XC3S200 FPGA Errata and Deviations from Spartan-3 Data Sheet

DS099-E03 (v2.2) December 20, 2004

Errata Notice

Figure 1: Spartan-3 FPGA from UMC 200 mm facility with “FQ” Fabrication/Process Code Marking

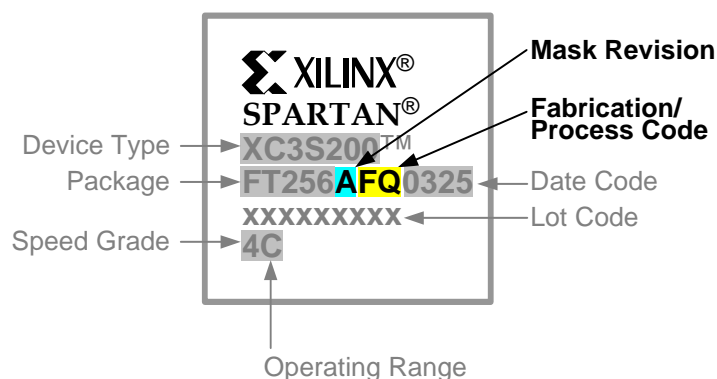
This issue only affects the XC3S200 FPGAs shown in [Table 4](#), marked with the “AFQ” mask/fabrication/process code as shown in [Figure 1](#).

The DCM compensates for delay on the routing network by monitoring an output clock, either CLK0 or CLK2X, through a BUFGMUX. If a design uses the CLK2X output as the feedback clock for a DCM, the LOCKED output may go Low and the DCM may stop operating correctly after tens of milliseconds.

This issue only affects the XC3S200 FPGAs shown in [Table 6](#), marked with the “AFQ” mask/fabrication/process code as shown in [Figure 1](#).

This issue only affects the XC3S200 FPGAs shown in [Table 7](#), marked with the "AFQ" mask/fabrication/process code as shown in [Figure 1](#).

Use feedback from the CLK0 (through a BUFGMUX) instead of CLK2X and change the CLK_FEEDBACK attribute from 2X to 1X. There is no difference in DCM performance. The CLK2X output is still valid and available for the application but it cannot be used for feedback to the CLKFB pin.

Do not shift a '0' into the HSWAP_EN position during device test using JTAG INTTEST. If the JTAG operation consistently drives HSWAP_EN High, then the PROG_B pin is never driven Low during the operation. However, the other dedicated configuration inputs may still see invalid values.

Configure with pull-ups active by driving HSWAP_EN Low. This is the recommended solution, as users should not rely on floating outputs to hold the value during configuration. The output behavior can be guaranteed if pull-ups are enabled.

Figure 2: Spartan-3 FPGA from UMC 300 mm facility with “GQ” Fabrication/Process Code Marking

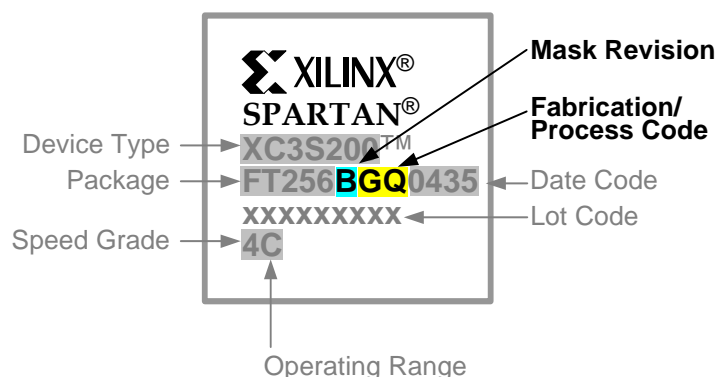
This issue only applies to those designs using the Readback feature on the XC3S200 FPGAs shown in [Table 8](#) with a "BGQ" Fabrication/Process Code marking, as shown in [Figure 2](#). Few Spartan-3 applications actually use the Readback feature. The CAPTURE_SPARTAN3 primitive is specifically required to use Readback.

The readback feature is not available.

This issue is corrected on XC3S200 FPGAs with a “BGQ” mask/fabrication/process code marking, as shown in [Figure 2](#).

This issue is corrected on XC3S200 FPGAs with a "BGQ" fabrication/process code marking, as shown in [Figure 2](#).

This issue is corrected on XC3S200 FPGAs with a "BGQ" fabrication/process code marking, as shown in [Figure 2](#).

Figure 3: Requirements when VCCINT is not the Last Supply

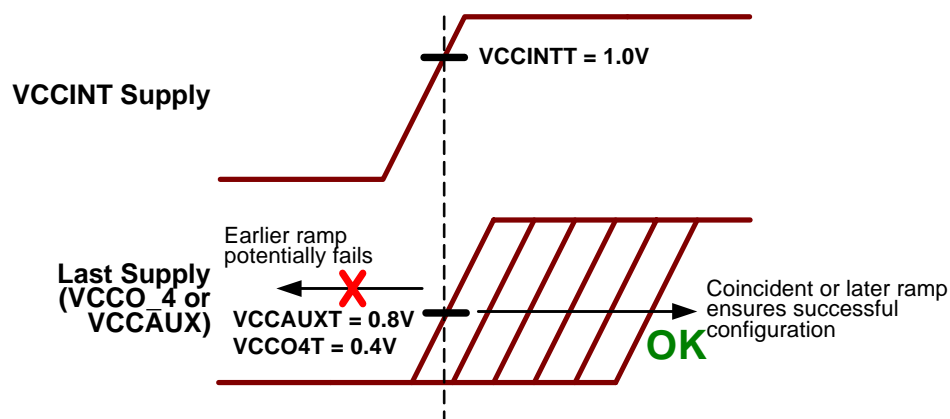
In the potentially failing condition, the VCCINT supply must be the last supply to reach its valid POR voltage and the ramp rate must be slower than 500 μ S. When the FPGA fails to configure, the INIT_B remains Low and the FPGA ignores the PROG_B program pin. Even with the worst identified power sequence, actual failures only occur on a small percentage of devices, typically measured in parts per million. The issue is more pronounced at cold temperatures.

VCCINT must reach its maximum POR threshold ($VCCINTT = 1.0V$) before or coincident with VCCAUX reaching its minimum threshold ($VCCAUXT = 0.8V$). This supply sequence and threshold relationship is illustrated in [Figure 3](#).

Alternatively, VCCINT must reach its maximum POR threshold ($VCCINTT = 1.0V$) before or coincident with VCCO_4 supplying I/O bank 4 reaching its minimum threshold ($VCCO4T = 0.4V$). This supply sequence and threshold relationship is also illustrated in [Figure 3](#).

Use a power-on sequence where VCCINT is not the last supply to reach its POR threshold level.

The lowest power-consuming sequence is to apply VCCAUX before or coincident with VCCINT, then VCCINT followed by VCCO_4. If VCCINT is applied before VCCAUX, the VCCINT supply consumes a surplus current until the VCCAUX supply reaches its maximum POR threshold, VCCAUXT. This additional current is a few hundred to several hundred milliamps (mA). This additional current is not required for successful configuration and the surplus current disappears when VCCAUX is applied.

Figure 4: Use Faster VCCINT Ramp Rate if VCCINT is Last Supply

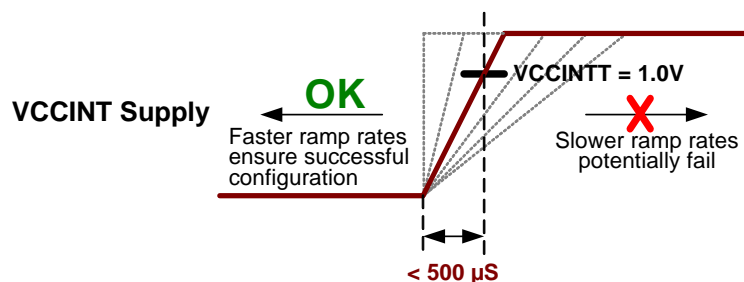
In a system that requires that the VCCINT supply is last in the power-up sequence, ensure that it ramps to its maximum POR threshold voltage ($VCCINTT = 1.0V$) in less than $< 500 \mu$ S, as shown in [Figure 4](#).

Figure 5: Enable User Editing in FPGA Editor

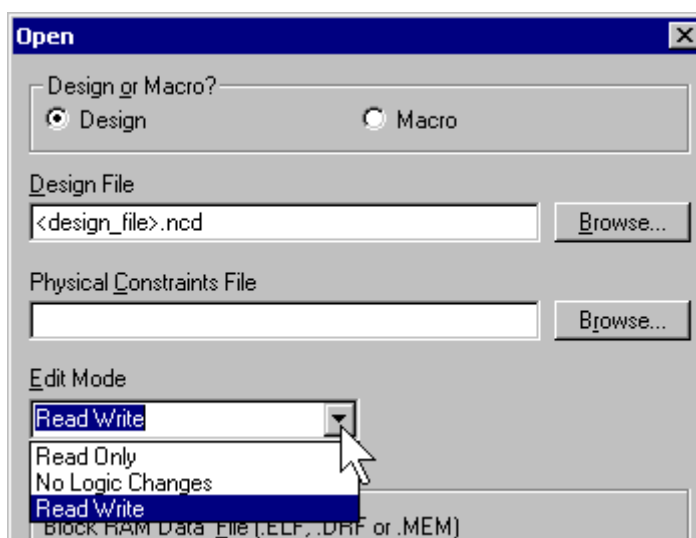
- Invoke the FPGA Editor. On Windows PCs, select **Start → Xilinx ISE 6 → Accessories → FPGA Editor**.
- Select **File → Open**. Select the *.ncd file for the completed design. Set the **Edit Mode** to "Read Write" mode as shown in [Figure 5](#).
